Yuba Community College District

New Softball Field

ADDENDUM NO. 1

Thursday, June 29, 2023

Client Project Number:	Client Proj.:
Scale:	Sheet:
Drawn By: Author	C3.1
Checked By: Checker	
Issue Date: Issue Date	
Revit Version: 2023	Sheet of _____

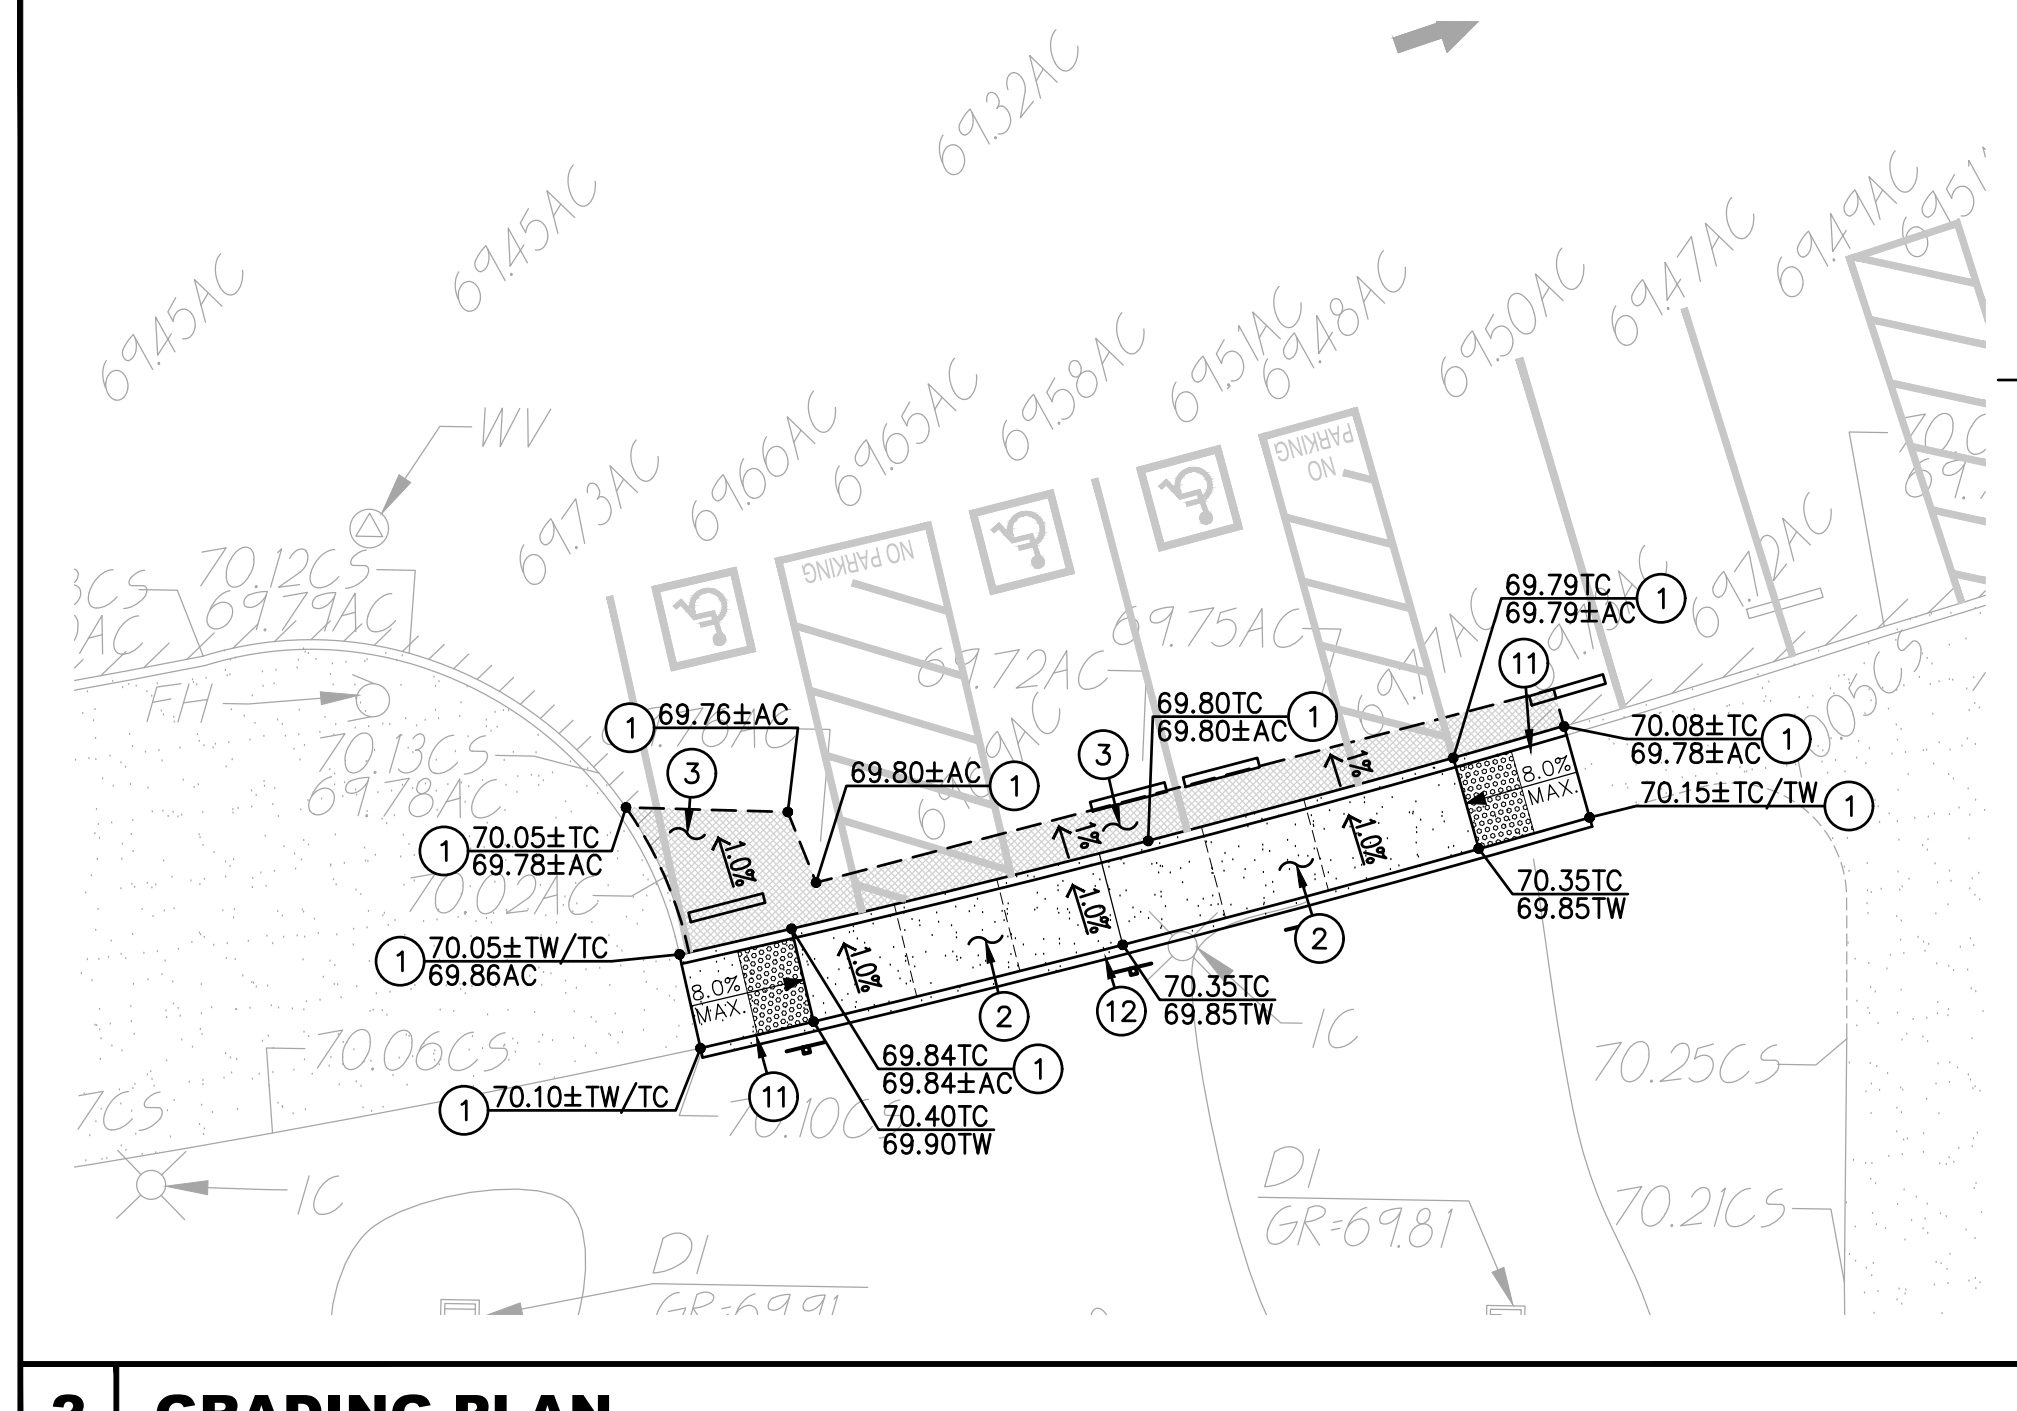
- A. **REVISE** Home and Visitors bullpen from dual to single pitching lanes.
- B. **REVISE** fencing limits. See updated coordinate points and dimensions.
- C. **REVISE** grades around bleachers to identify the sidewalk grades in and around the bleacher support slabs.
- D. **REVISE** keyed note 18 to include reinforced, concrete support slab/footings. Bleacher slab/footings are separate from the sidewalk slabs. Refer to manufacturer's drawings for concrete slab/footing requirements.
- E. **REVISE** location of floor drain behind center bleacher slightly.
- F. **REVISE** pavement joint pattern to coordinate with new bleacher slab/footings.

Client Project Number:	Client Proj.
Scale:	Sheet
Drawn By: Author	C3.3
Checked By: Checker	
Issue Date: Issue Date	
Revit Version: 2023	
Sheet	of _____

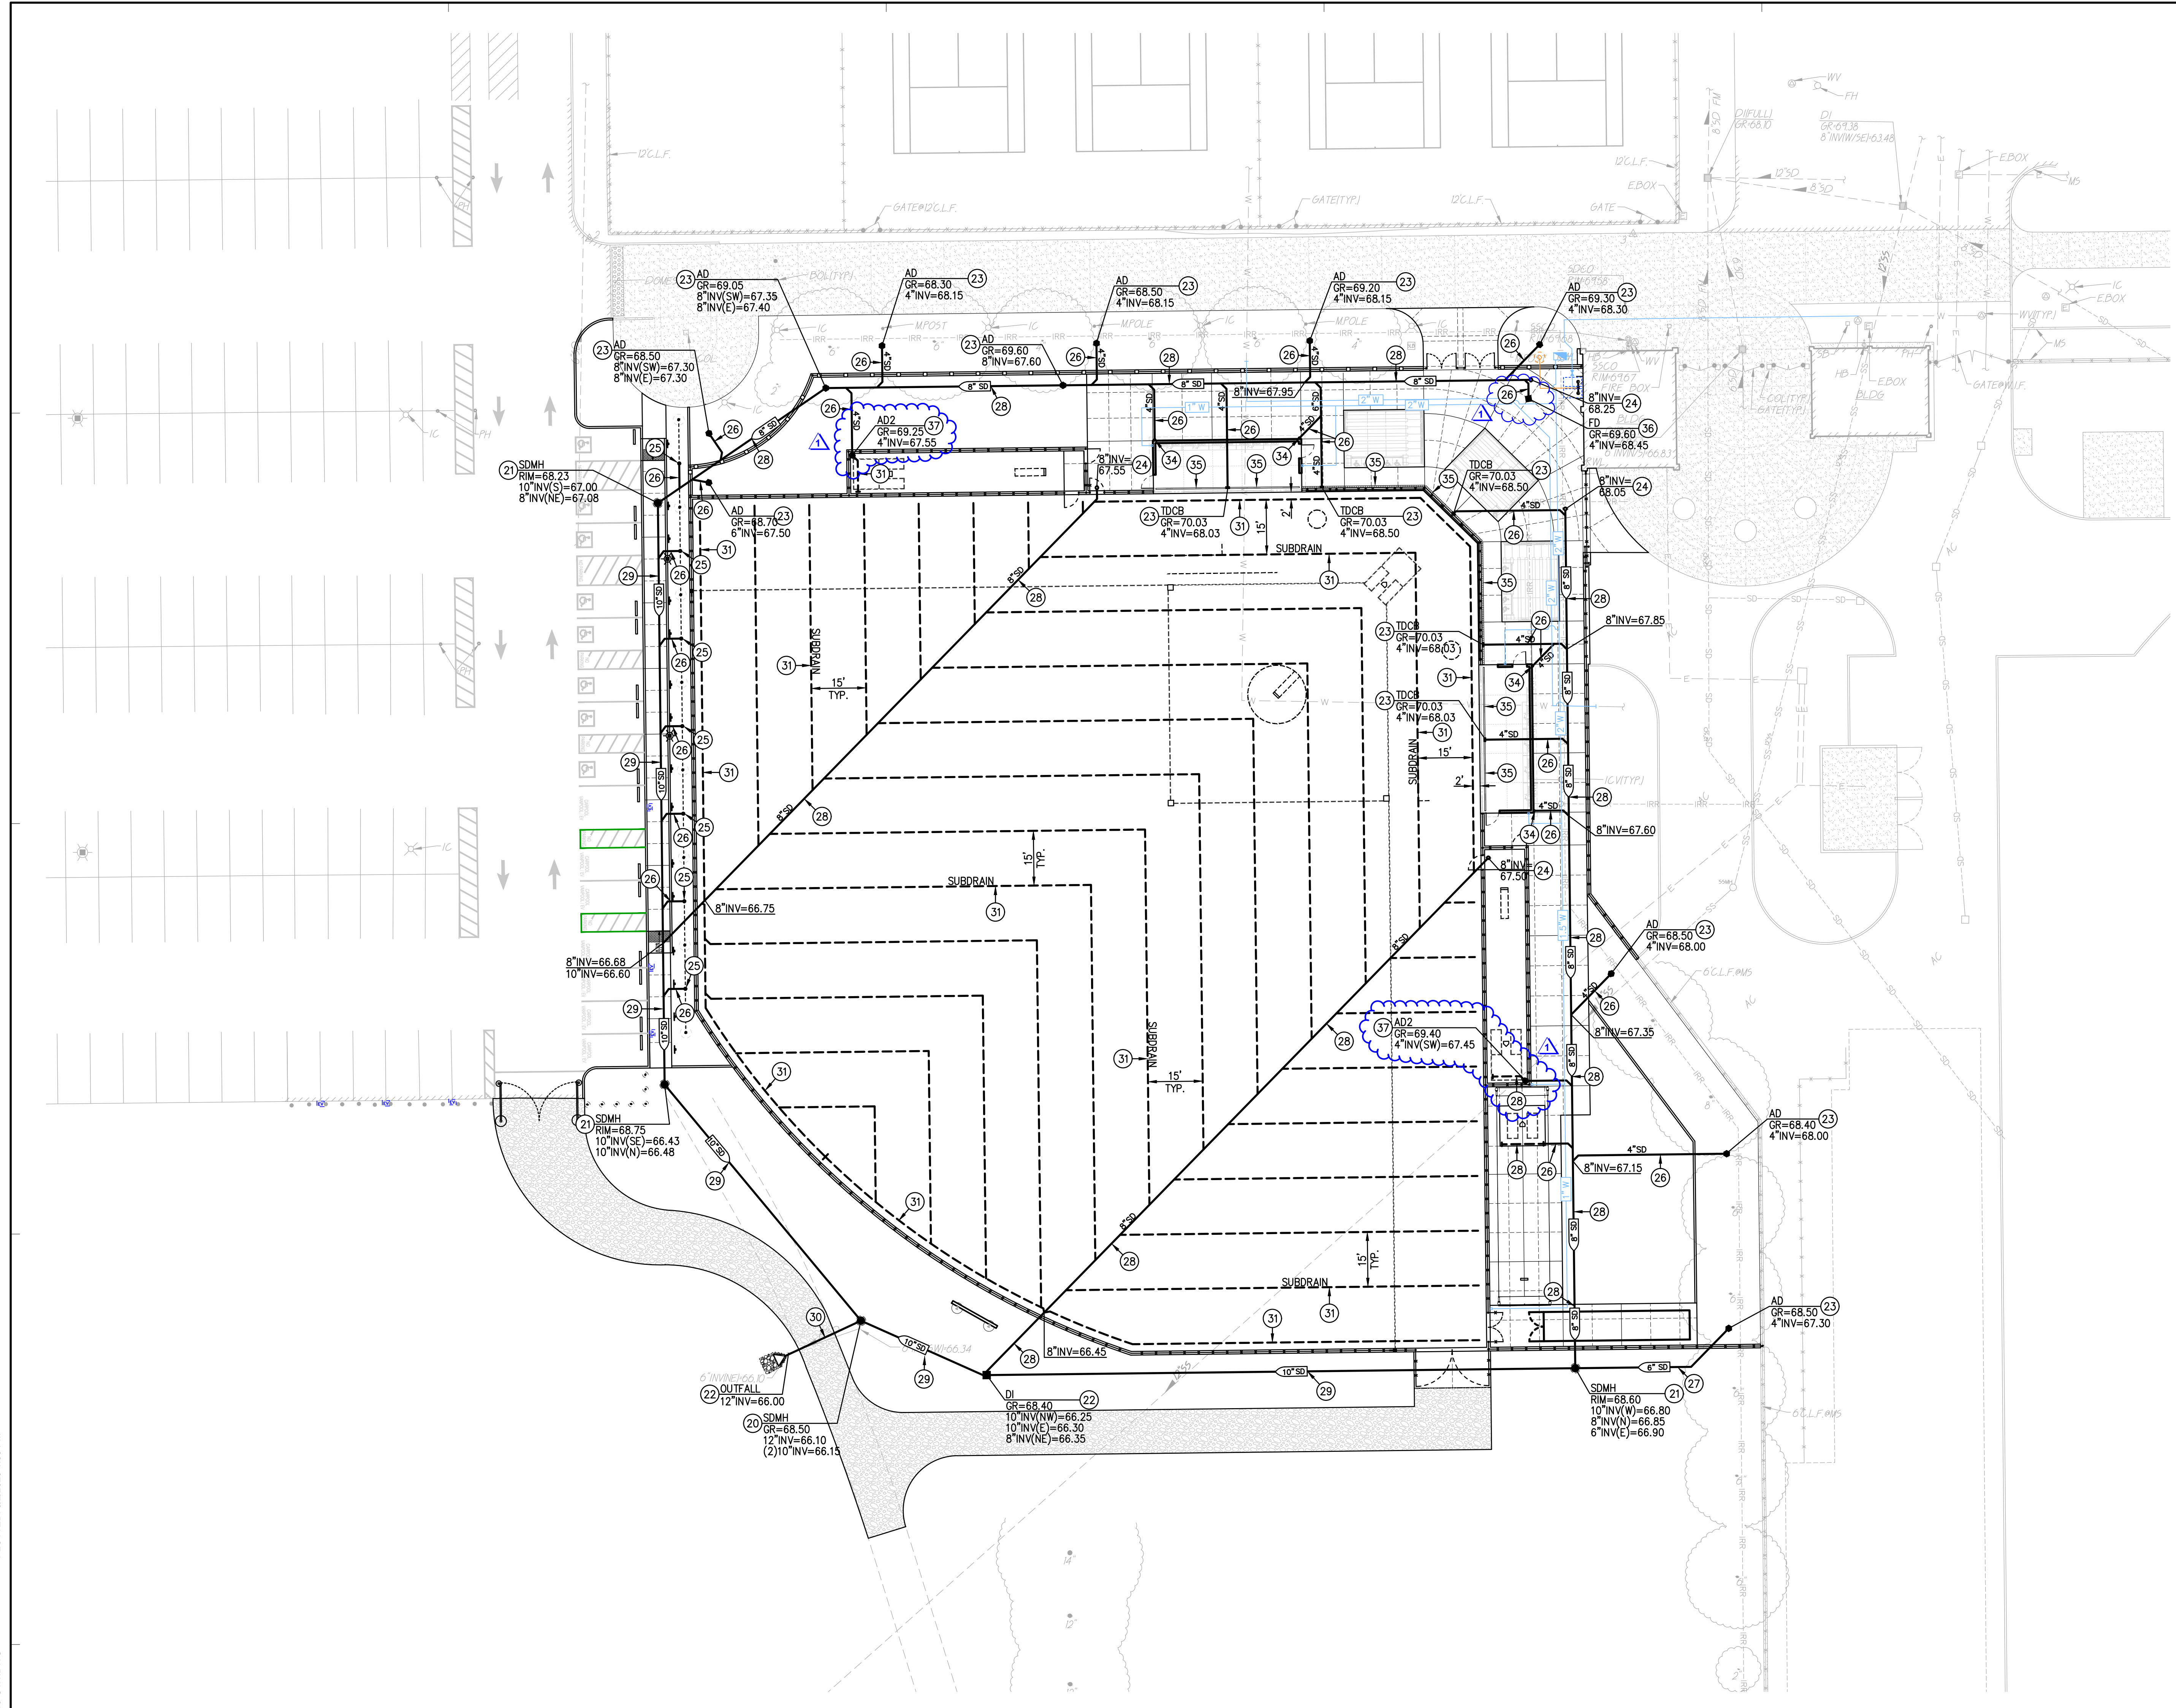
- A. **REVISE** Home and Visitors bullpen from dual to single pitching lanes.
- B. **REVISE** fencing limits. See updated coordinate points and dimensions.
- C. **REVISE** keyed note 18 to include reinforced, concrete support slab/footings. Bleacher slab/footings are separate from the sidewalk slabs. Refer to manufacturer's drawings for concrete slab/footing requirements.

Client Project Number:	Client Proj:
Scale:	Sheet
Drawn By: Author	C4.1
Checked By: Checker	
Issue Date: Issue Date	
Revisi Version: 2023

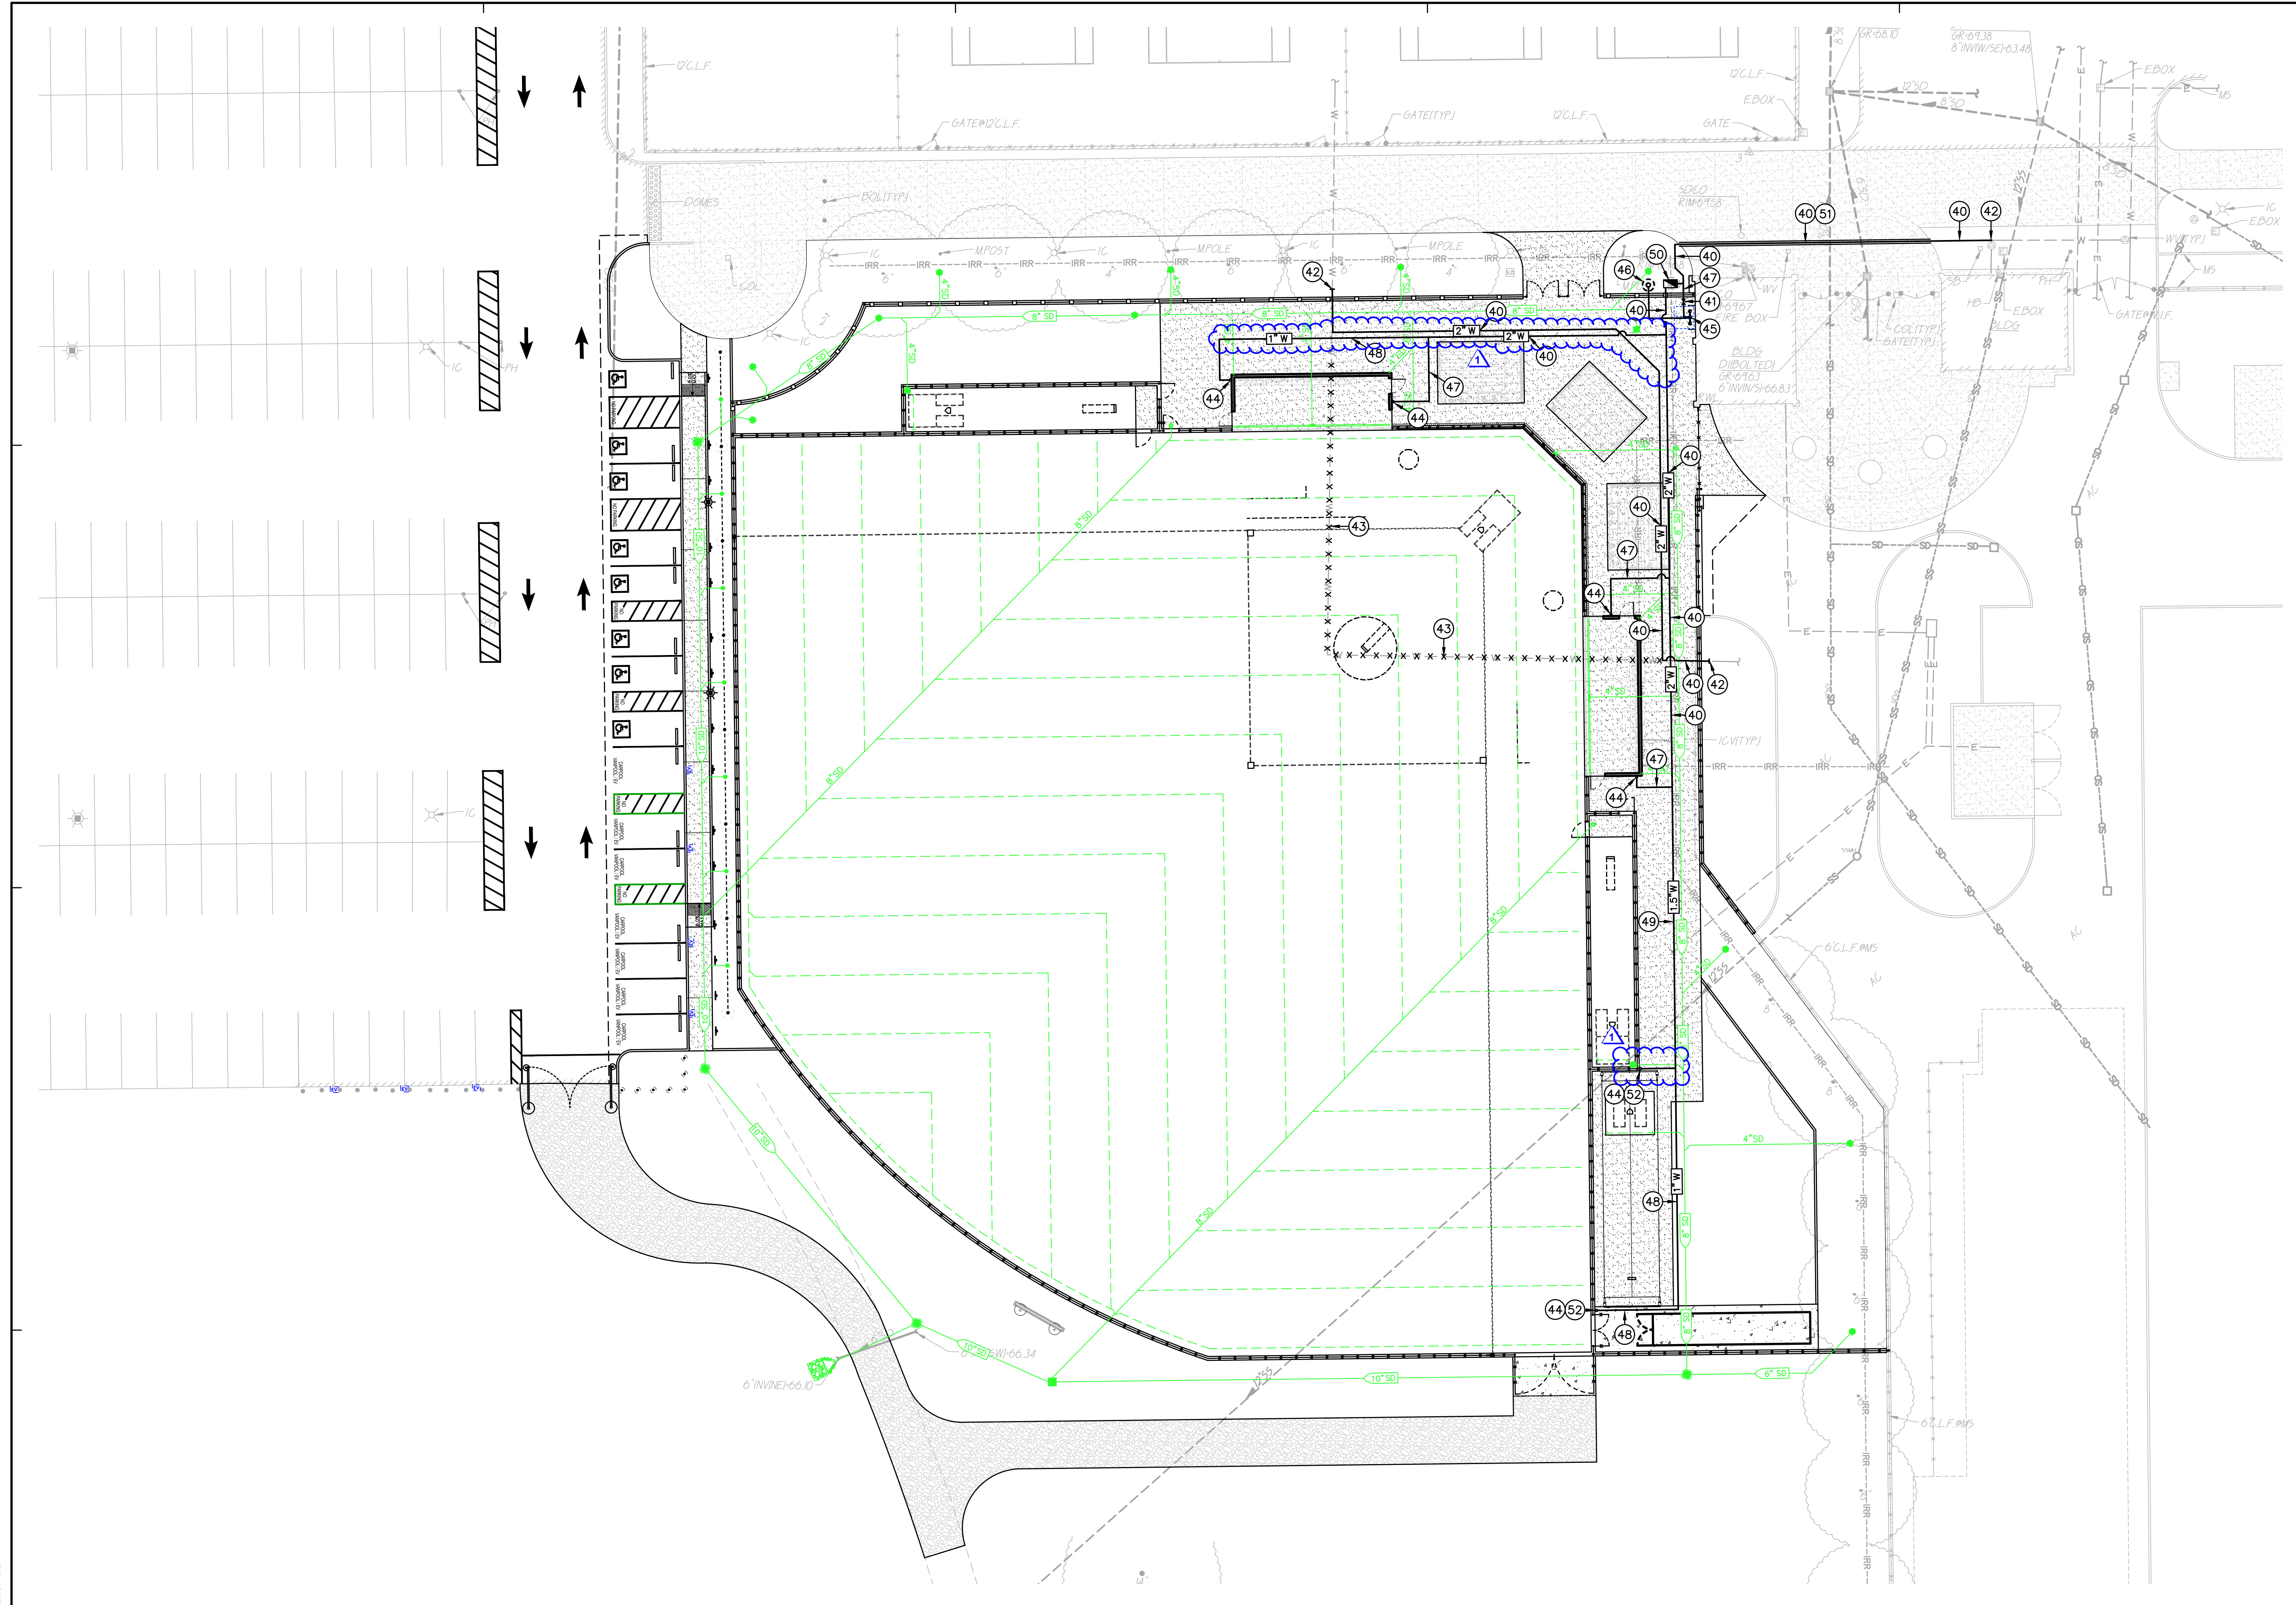
- A. **REVISE** Home and Visitors bullpen from dual to single pitching lanes.
- B. **REVISE** location of drains in bullpens and change elevations as noted on sheet.
- C. **REVISE** length of lateral connecting pipe to meet new drain locations.
- D. **REVISE** location of floor drain behind center bleacher.

Client Project Number:	Client Proj.
Scale:	Sheet
Drawn By: Author	C4.2
Checked By: Checker	
Issue Date: Issue Date	
Revit Version: 2023	
Sheet	of _____

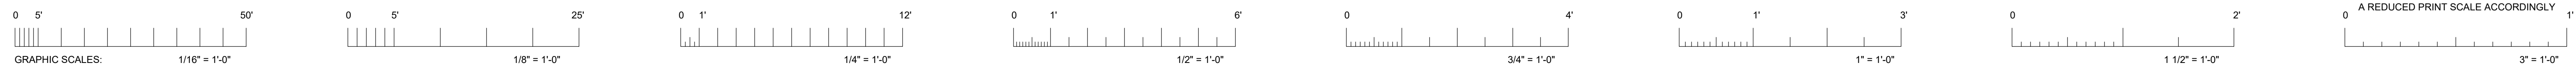
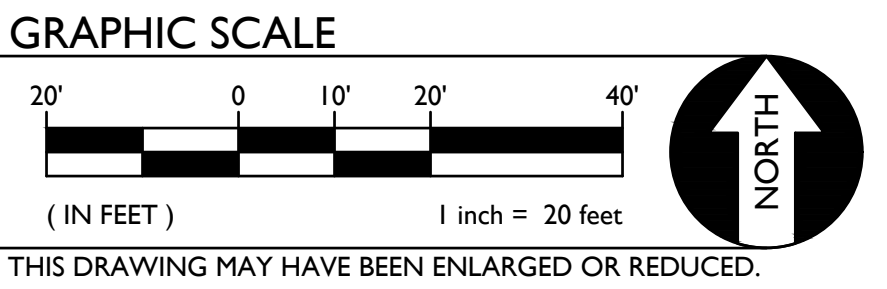
- A. **REVISE** location of water lines so they are not under proposed bleacher slabs.
- B. **REVISE** location of water hose riser west of new bullpen fence line location. Extend connecting pipe.
